February 24, 2015

Attn: Mr. Kevin Null
Subj: Clarifications to the Combined Application for a License to Produce and Possess
Accelerator Produced Radionuclides for Research and Development (NRC Control No.
584728)

1. RAM Upgrade

Figure 1: Drawing showing external of RAM Storage and Spectroscopy Lab enclosure.

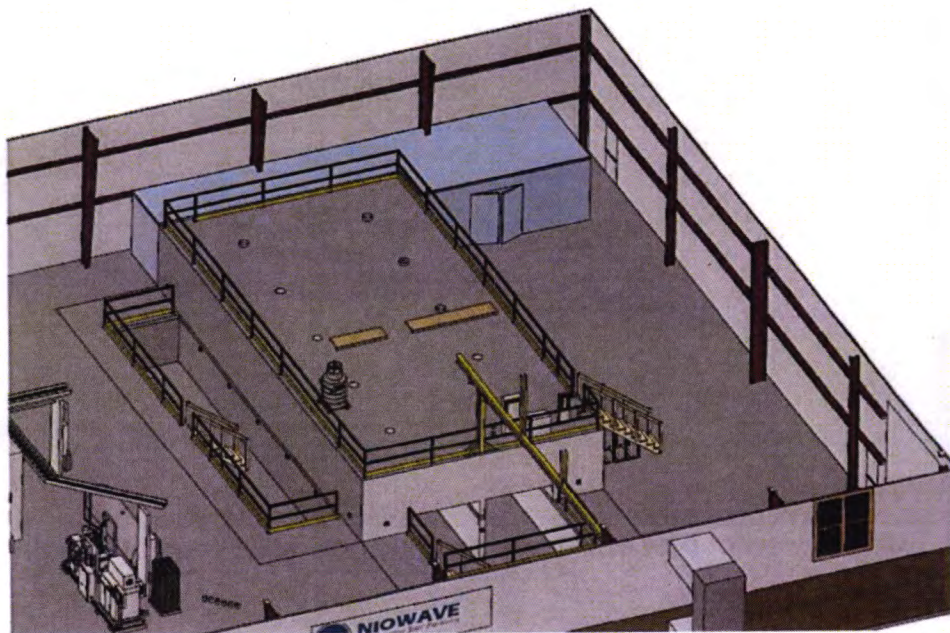
1. Upgrade of the RAM storage area
2. Our intentions to keep the target intact and not to separate any fission products from the uranium targets
3. Estimates of the incidentally produced radioisotopes

Niowave has completed an upgrade to our RAM storage enclosure. We have fully enclosed the storage area with solid walls and a roof as well as a lockable chain-link gate (see Figures 1-4). The gate can only be accessed thru the spectroscopy lab, which is locked at all times when not occupied by applied physics personnel. Originally there was only a single layer of chain-link wall and no roof enclosing the storage area. The RAM storage vault is now among the most secure locations in our facility. Images of the upgraded enclosure can be found in the figures below.
